SUBJECT: QUAD CITIES - ISSUANCE OF AMENDMENTS - REVISED PRESSURE-TEMPERATURE LIMITS (TAC NOS. MA7138 AND MA7139)

QUAD CITIES NUCLEAR POWER STATION, UNIT 1

Amendment No. 195
License No. DPR-29

SAFETY EVALUATION BY THE OFFICE OF NUCLEAR REACTOR REGULATION

FIGURE 3.6.K-1

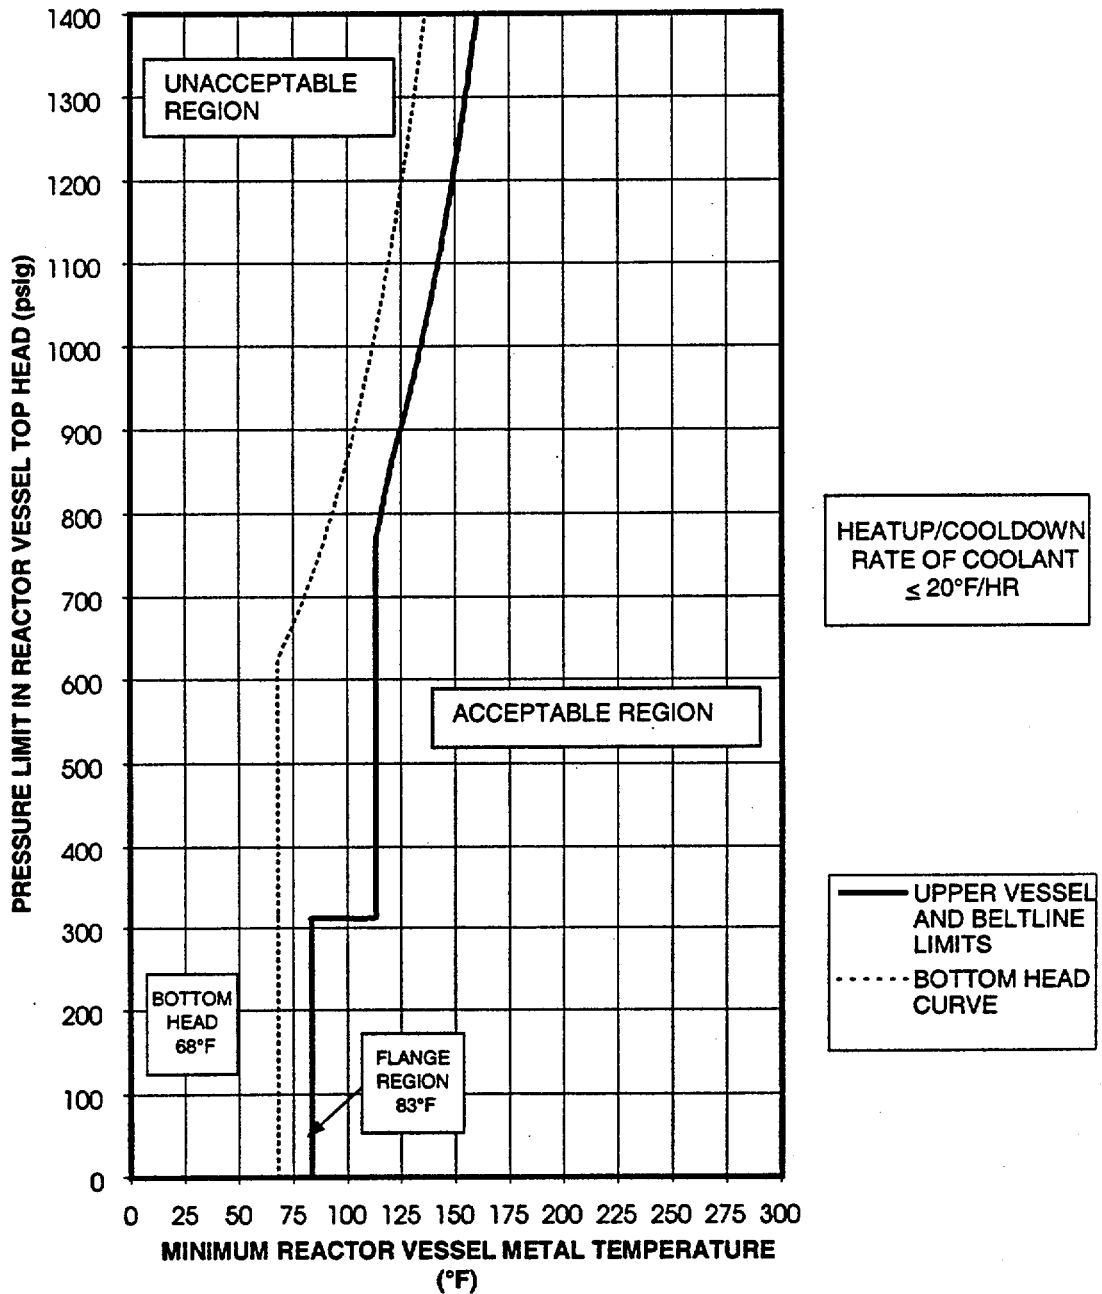
As indicated in Figure 3.3.6.K-1 for pressure testing, the minimum metal temperature of the reactor vessel shell is 83°F for reactor pressures less than 312 psig. This 83°F minimum boltup temperature is based on a RT_{NDT} of 23°F for the electroslag weld immediately below the vessel flange and a 60°F conservatism required by the original ASME Code of construction. The bottom head region limit is established as 68°F, based on moderator temperature assumptions for shutdown margin analyses. At reactor pressures greater than 312 psig, the minimum vessel metal temperature is established as 113°F. The 113°F minimum temperature is based on a closure flange region RT_{NDT} of 23°F and a 90°F conservatism required by 10CFR Part 50 Appendix G. Beltline curves as a function of vessel exposure for 32 effective full power years (EFPY) are presented.

Figure 3.6.K-1 is governing for applicable pressure testing with a maximum heatup/cooldown rate of 20°F/hour.

The staff performed an independent calculation of the ART values for the limiting material using the methodology in RG 1.99, Revision 2. Based on these calculations, the staff verified that the licensee's limiting material for Quad Cities Nuclear Power Station, Units 1 and 2, reactor vessel is the electro-slag axial welds. The staff's calculated ART value for the limiting material agrees with the licensee's calculated ART value. Further, except for the bounding fluence value assumed by the licensee, the material data for all beltline materials reported in this submittal is consistent with that in the NRC's reactor vessel integrity database (RVID).

For the beltline P-T limits, the licensee provided detailed calculations for a sample point on each P-T curve. The staff examined the sample calculations, and verified that the licensee's proposed beltline P-T limits satisfy the requirements in Paragraph IV.A.2 of Appendix G of 10 CFR Part 50 as modified by Code Cases N-588 and N-640. It should be noted that the staff did not approve the simplified approach of manipulating the thermal gradient stress at the 1/4T for heatup so that P-T limits at 3/4T can be evaluated at 1/4T using the ART of 1/4T. The qualitative analysis for using this approach is not sufficient to demonstrate the validity of this simplified approach for all vessels. However, the staff has performed conventional calculations for the heatup P-T limit curve not using this assumption to ensure that the heatup P-T limits are bounded by the proposed P-T limit curve. Further, since the limiting material is axial welds and the use of the modified stress intensity factor K_{Im} due to membrane tension for axial flaws are not significantly different from that in the 1989 ASME Code, the benefit from applying Code Case N-588 in this application is not significant.

Thus, the staff determined that the licensee's proposed P-T limit curves were acceptable, since they meet the intent of the requirements of 10 CFR 50.60 and Appendix G of 10 CFR Part 50.

FIGURE 3.6.K-2
PRESSURE - TEMPERATURE LIMITS FOR NON-NUCLEAR
HEATUP/COOLDOWN - VALID TO 32 EPFY

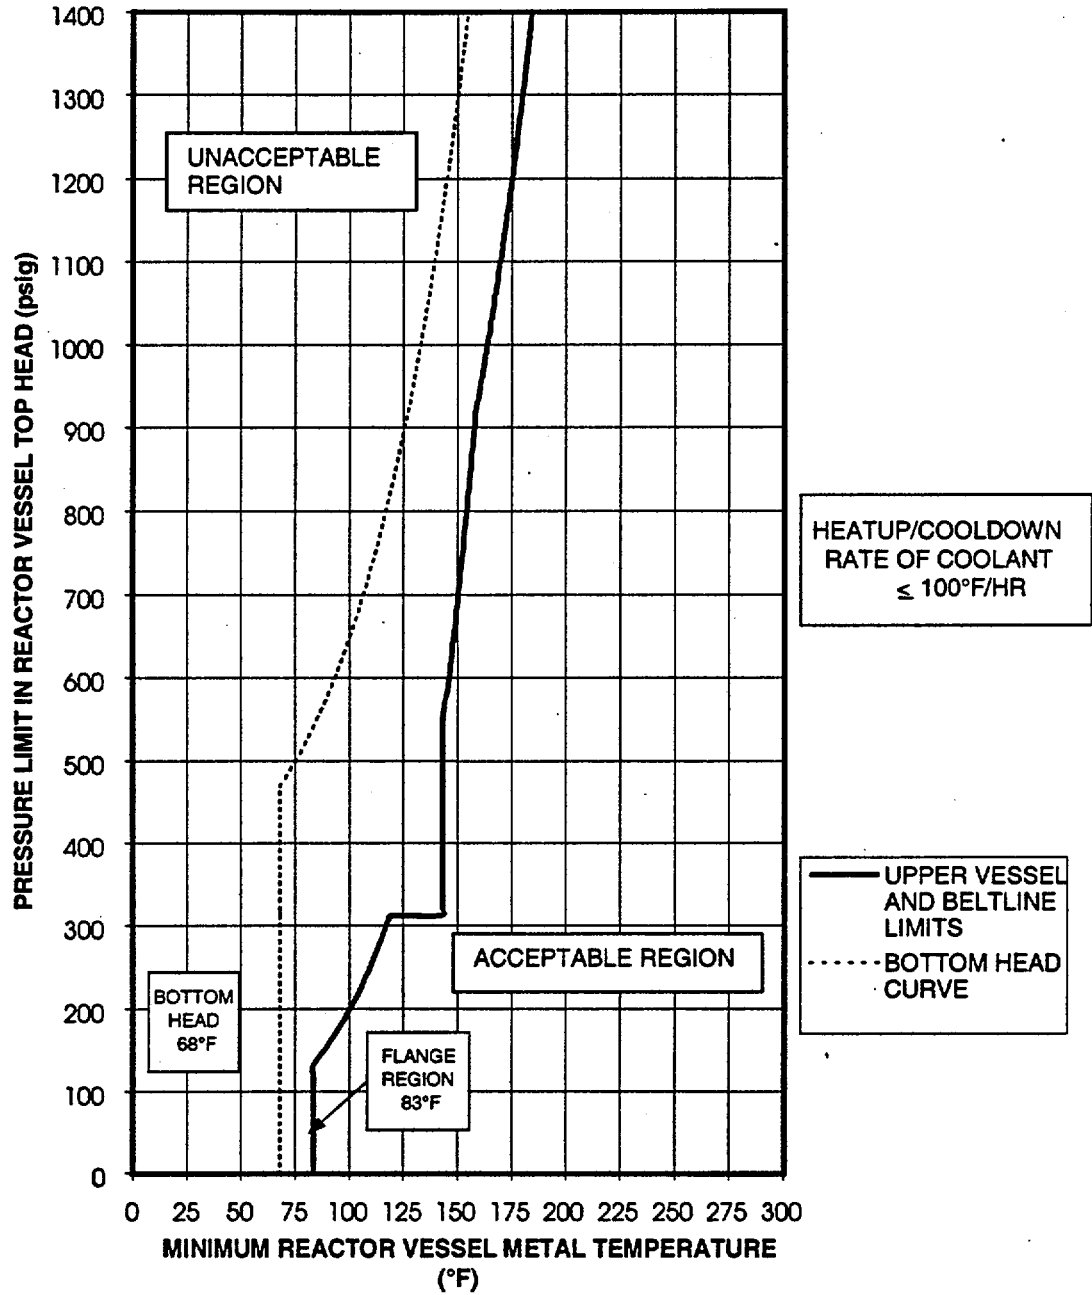
Figure 3.6.K-2 applies during heatups with non-nuclear heat (e.g., recirculation pump heat) and during cooldowns when the reactor is not critical (e.g., following a scram). The curve provides the minimum reactor vessel metal temperatures based on the most limiting vessel stress. The maximum heatup/cooldown rate of 100°F/hour is applicable.

FIGURE 3.6.K-3
PRESSURE - TEMPERATURE LIMITS FOR CRITICAL
CORE OPERATIONS - VALID TO 32 EFY

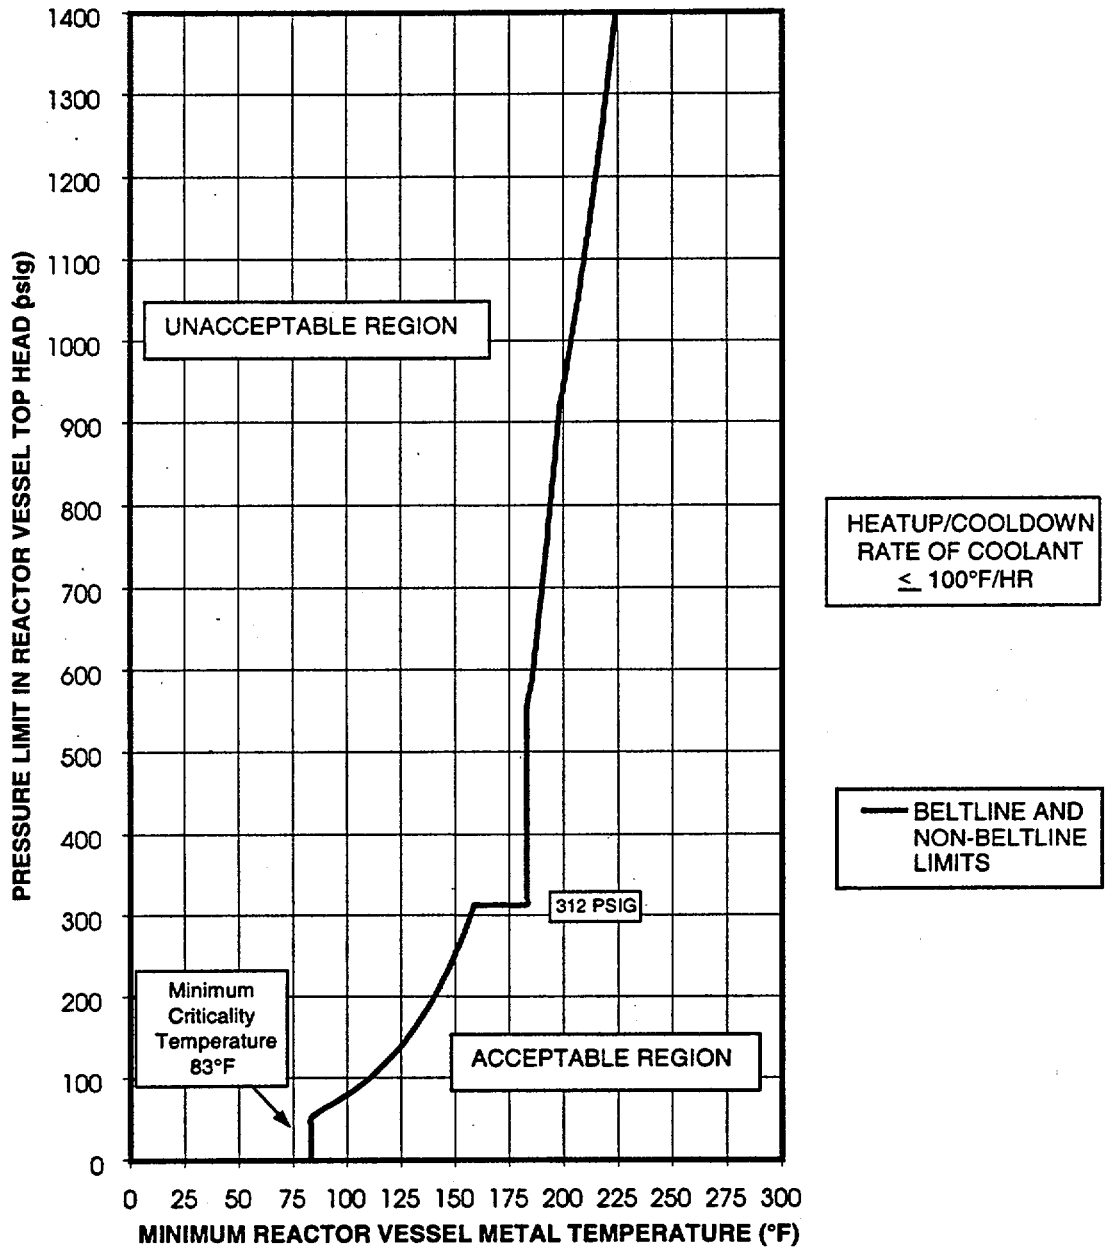
The core critical operation curve shown in Figure 3.6.K-3, is generated in accordance with 10CFR Part 50 Appendix G which requires core critical pressure-temperature limits to be 40°F above any Pressure testing or non-nuclear heatup/cool-down limits.
